TOYOTA Service Bulletin

Section :	Body Electrical
Ref. No. :	BE-0020
Date :	Jul., 2000
Page :	1 of 2

Model Name : LAND CRUISER

Subject : SUPPLEMENTAL FOR REPAIR MANUAL

I01673

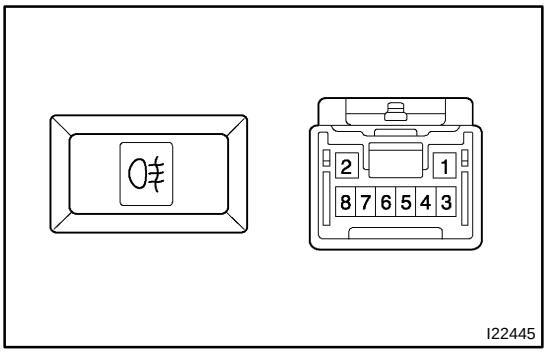
This Service Bulletin is to inform you of the inspection procedure for rear fog light system due to the change of the rear fog light switch from July, 2000.

1. INSPECT REAR FOG LIGHT SWITCH CONTINUITY

Switch position	Tester connection	Specified condition
OFF	-	No continuity
ON	2 - 5	Continuity
Illumination circuit	2 - 8	Continuity

2. INSPECT REAR FOG LIGHT SWITCH CIRCUIT

Disconnect the connector from the switch and inspect the connector on the wire harness side.

Tester connection	Condition	Specified condition
1 - Ground	Constant	* Continuity
4 - Ground	Constant	Continuity
5 - Ground	Light control switch HEAD	Continuity
7 - Ground	Constant	Continuity
2 - Ground	Light control switch TAIL or HEAD	Battery voltage
3 - Ground	Constant	Battery voltage

If continuity is not as specified, replace the switch.

If circuit is not as specified, replace the wire harness.
